ECE/TRANS/WP.29/GRRF/2008/15
7 July 2008

**REGULATIONS Nos. 13 AND 13-H
(Braking)**

Brake Assist System

Proposal for draft amendments to Regulation No. 13-H

Figure 1a: Pedal force characteristic needed in order to achieve maximum deceleration with category "A" BAS

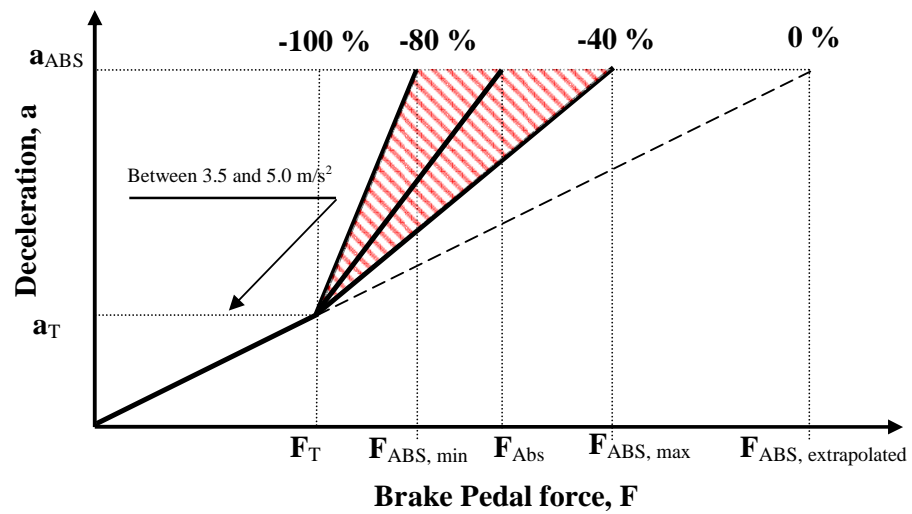
- 3.2.3. F_T and a_T are threshold force and threshold deceleration as shown in Figure 1. The values of F_T and a_T shall be supplied to the Technical Service at the time of submission of the type-approval application. The value of a_T shall be between 3.5 m/s² and 5.0 m/s².

- 3.2.4. A straight line is drawn from the origin through the point F_T, a_T (as shown in Figure 1a). The value of brake pedal force "F", at the point of intersection between this line and a horizontal line defined by $a=a_{ABS}$, is defined as $F_{ABS, extrapolated}$:

$$F_{ABS, extrapolated} = \frac{F_T \cdot a_{ABS}}{a_T}$$

Figure 1b: Pedal force characteristic needed in order to achieve maximum deceleration with category "A" BAS

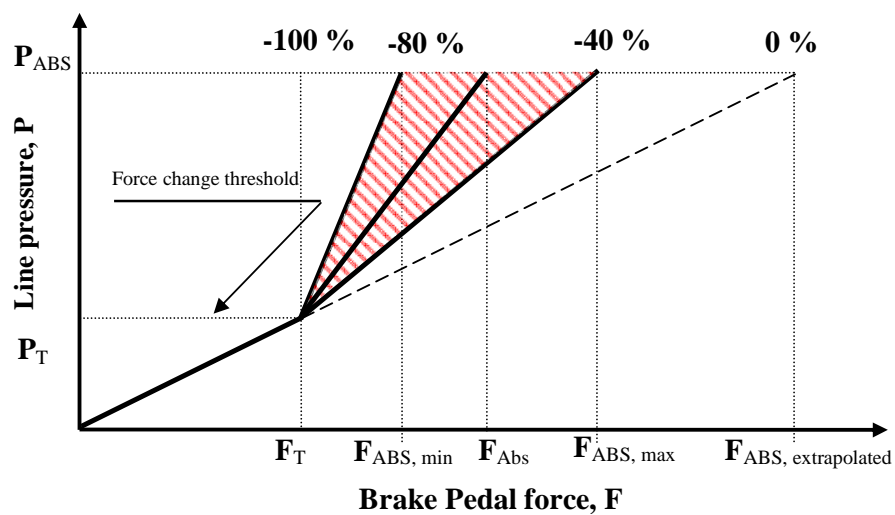
- 3.2.5. As an alternative, which can be selected by the manufacturer, [in the case of vehicles of Category N₁ > 2.5 tonnes], the pedal force figures for $F_T, F_{ABS, min}, F_{ABS, max}$ and $F_{AB, extrapolated}$ may be derived from the brake line pressure response characteristic instead of the vehicle deceleration characteristic. This shall be measured as the brake pedal force is increasing.

- 3.2.5.1. The pressure, at which ABS cycling commences, shall be determined by making five tests from 100 ± 2 km/h in which the brake pedal is applied up to the level which produces ABS operation and the five pressures at which this occurs as determined from front wheel pressure records, shall be recorded and the mean value obtained as P_{ABS} .

- 3.2.5.2. The threshold pressure P_T shall be stated by the manufacturer and correspond to a deceleration in the range of 2.5 - 4.5 m/s².
- 3.2.5.3. Figure 1b shall be constructed in the manner set out in paragraph 3.2.4., but using line pressure measurements to define the parameters set out in paragraph 3.2.5. above where:

$$F_{ABS, extrapolated} = \frac{F_T \cdot P_{ABS}}{P_T}$$

Figure 2: Example of test 2 of a category "B" BAS system

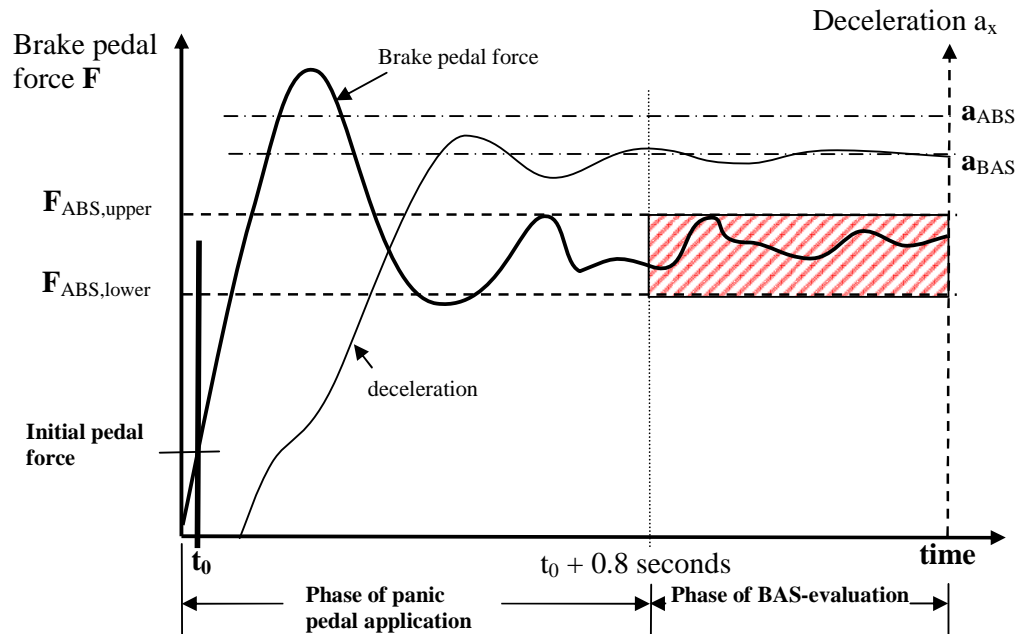
The vehicle shall be driven in a straight line at the test speed specified in paragraph 2.4. above. The driver shall apply the brake pedal quickly according to Figure 2, simulating emergency braking so that BAS is activated and ABS is fully cycling.

In order to activate BAS the brake pedal shall be applied as specified by the car manufacturer. The manufacturer shall notify the Technical Service of the required brake pedal input at the time of submission of the application for type-approval. It shall be demonstrated to the satisfaction of the Technical Service that the BAS activates under the conditions specified by the manufacturer in accordance with paragraph 22.1.2. or 22.1.3.

After $t = t_0 + 0.8$ s and until the vehicle has slowed down to a speed of 15 km/h, the brake pedal force shall be maintained in a corridor between $F_{\text{ABS, upper}}$ and $F_{\text{ABS, lower}}$. Where $F_{\text{ABS, upper}}$ is $0.7 F_{\text{ABS}}$ and $F_{\text{ABS, lower}}$ is $0.5 F_{\text{ABS}}$.

The requirements are also considered to be met if, after $t = t_0 + 0.8$ s, the pedal force falls below $F_{\text{ABS, lower}}$ provided the requirement of paragraph 4.3. is fulfilled.

Figure 3: Deceleration corridor for determination of F_{ABS} and a_{ABS}

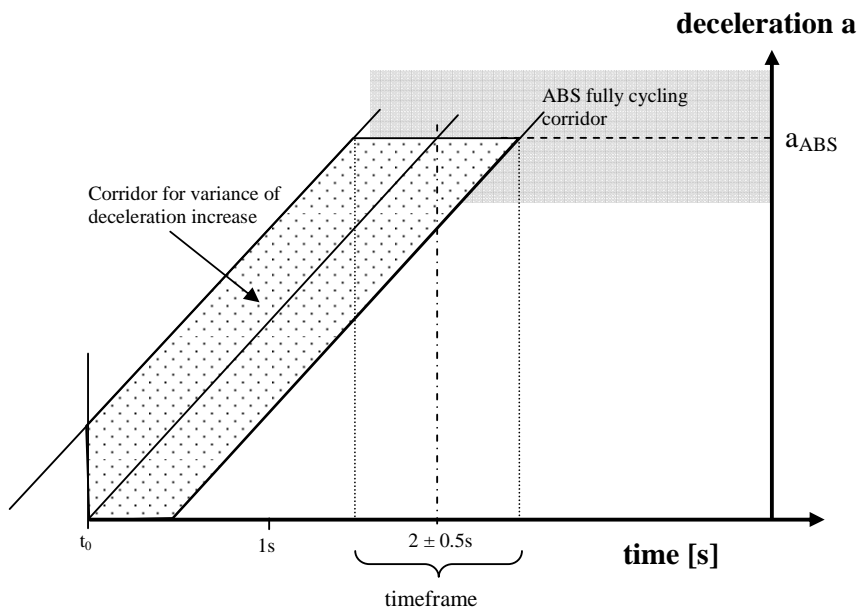
- 1.2. The brake pedal shall be applied slowly (without activating the BAS in the case of category B or category C systems) providing a constant increase of deceleration until ABS is fully cycling (Figure 3).

- 1.3. The full deceleration must be reached within the timeframe of 2.0 ± 0.5 s. The deceleration curve, recorded against time, must be within a corridor of ± 0.5 s around the centre line of the deceleration curve corridor. The example in Figure 3 has its origin at the time t_0 crossing the a_{ABS} line at 2 seconds. Once full deceleration has been achieved the pedal travel S_p shall not be decreased for at least 1 s. The time of full activation of the ABS system is defined as the time when pedal force F_{ABS} is achieved. The measurement shall be within the corridor for variance of deceleration increase (see Figure 3).
